**UNITED STATES
NUCLEAR REGULATORY COMMISSION**
WASHINGTON, D.C. 20555-0001

LICENSEE: Indiana Michigan Power Company

FACILITY: Donald C. Cook Nuclear Plant, Units 1 and 2

SUBJECT: SUMMARY OF AUGUST 26, 2009, CATEGORY 1 PUBLIC MEETING VIA CONFERENCE CALL TO DISCUSS RESPONSES TO GENERIC LETTER 2004-02 REQUESTS FOR ADDITIONAL INFORMATION (TAC NOS. MC4679 AND MC4680)

Figure 7.a-1: Data Erosion Rate and Predicted Cumulative % Weight Loss Curve (Thermo-12™ Gold)

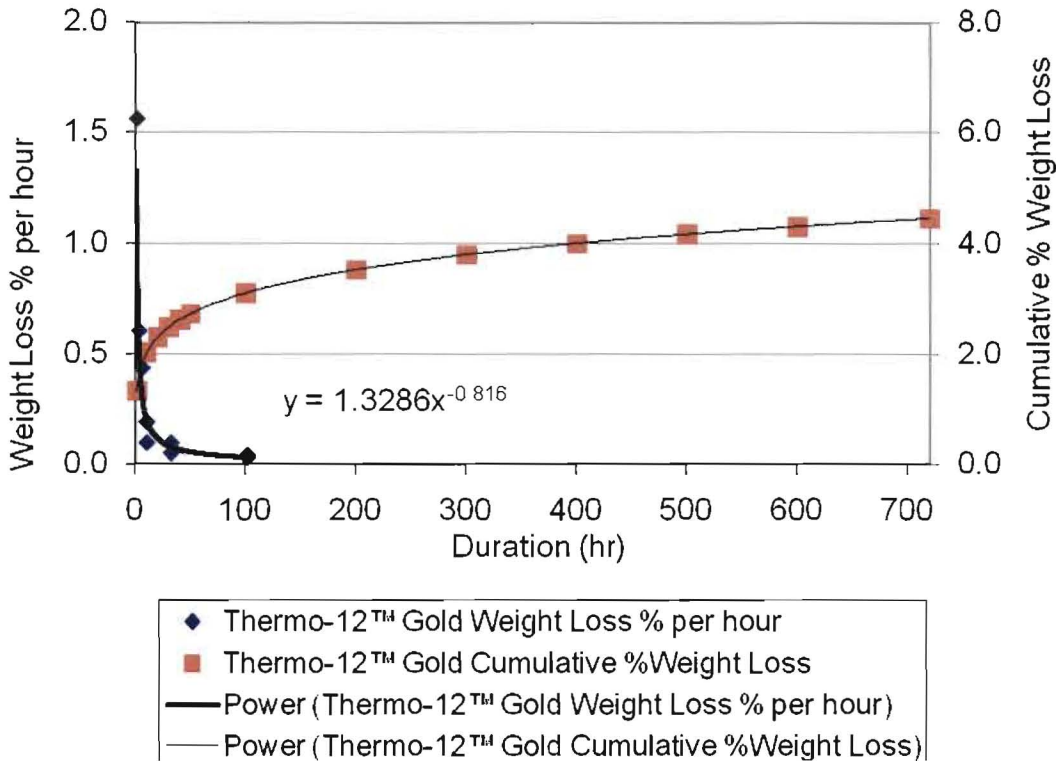
7. *Please provide additional information concerning the erosion testing of calcium silicate insulation and Marinite board, including the following items:*
 - a) *The basis for not accounting for erosion and dissolution effects in combination. The presence of chemicals in the test fluid may enhance the erosion rate, and, conversely, a high erosion rate may lead to increased dissolution.*

The data collected during Thermo-12™ Gold flow erosion testing was analyzed in the Cal-Sil Flow Erosion Testing Report. The data in Figure 7.a-1 represents the rate of erosion of Thermo-12™ Gold Cal-Sil as presented in Figure 3.2-3 of Cal-Sil Flow Erosion Testing Report. The equation from 3.2-3 (i.e. $y = 1.3286x^{-0.816}$) is used to calculate the cumulative % weight loss data and the curve generated from this data is presented in Figure 7.a-1 as well.

During the conduct of the testing, one of the overall observations made was that during the initial stages of all tests, small amounts of particles detached from the samples. This behavior is most likely due to the washing of loosely attached pieces. The graph above shows the behavior that the majority of flow erosion occurs in the initial hours and then the rate of erosion continuously declines as time increases.

Extending the curve for cumulative % weight loss, the weight loss at 720 hours is 4.46%. Although the data plotted above indicates that the erosion rate may decrease with time, a linear curve fit was applied to the data as a more conservative method of extrapolation due to its application of a constant erosion rate as opposed to a power curve fit. Figure 3.2-2 of Cal-Sil Flow Erosion Testing Report (Figure 7.a-2) represents the linear curve fit. In addition to Thermo-12™ Gold Cal-Sil cumulative erosion, also displayed are values for four types of plant provided Cal-Sil cumulative erosion.

2. The method of calculating the Cal-Sil and Marinite flow erosion at 30 days is highly conservative:
 - a. Extending the curve for cumulative weight loss, the weight loss at 30 days for Thermo-12™ Gold is 4.46% (As shown in Figure 7.a-1).

- b. Although the data plotted in Figure 7.a-1 indicates that the erosion rate may decrease with time, a linear curve fit that was applied to the data as a more conservative method of extrapolation due to its application of a constant erosion rate as opposed to a power curve fit (As shown in Figure 7.a-2). The total weight loss of Cal-Sil samples calculated in this manner at 30 days is (15.37 ± 0.59)%.

Figure 7.c-1: Average velocity in non-transport regions for small pieces of Cal-Sil and Marinite

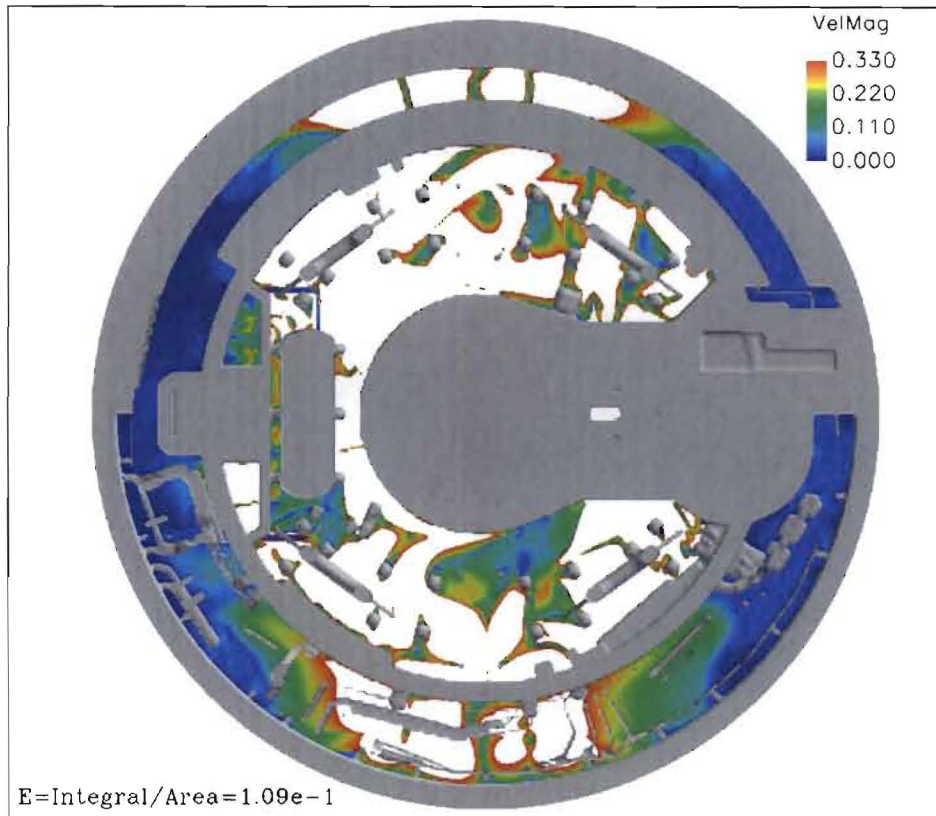
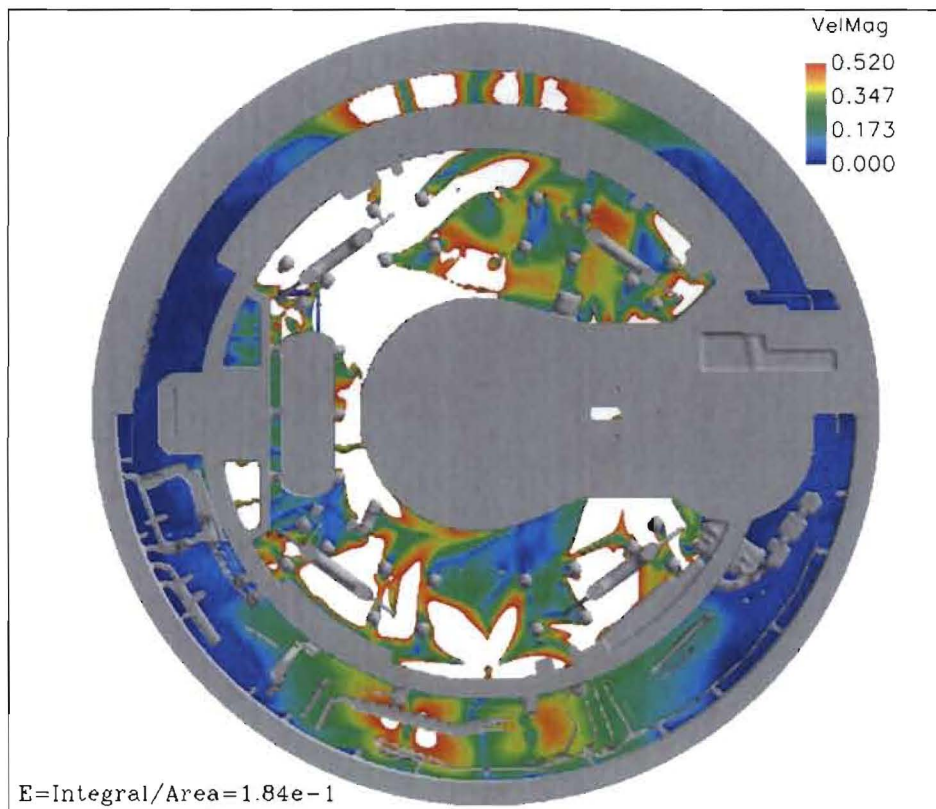
- c) *The basis for using a velocity of 0.4 ft/s, since calcium silicate pieces larger than those tested (i.e., in the large piece category) would not transport at this velocity based on the metric of 0.52 ft/s cited in Table 3e1-5 in the February 29, 2008 supplemental response. As a result of exposure to higher velocity flows than tested, erosion from settled large pieces of calcium silicate could be underestimated.*

The tumbling velocity that was used for small pieces of Cal-Sil and Marinite debris is 0.33 ft/s, and the tumbling velocity that was used for large pieces of Marinite debris is 0.52 ft/s. Since these pieces of debris would transport in any regions of the pool where the velocities are higher, the erosion would apply to debris that does not transport in the lower velocity regions. The recirculation pool CFD results from the limiting break case (Loop 4) were analyzed to determine the average velocity in the non-transport regions. As shown in Figure 7.c-1 and Figure 7.c-2, the average velocity in the non-transport regions was determined to be 0.11 ft/s for small pieces of Cal-Sil and Marinite, and 0.18 ft/s for large pieces of Marinite. Since these velocities are significantly lower than the 0.4 ft/s velocity used for the erosion tests, the erosion testing can be conservatively used for both the small and large pieces of Cal-Sil and Marinite at D.C. Cook.
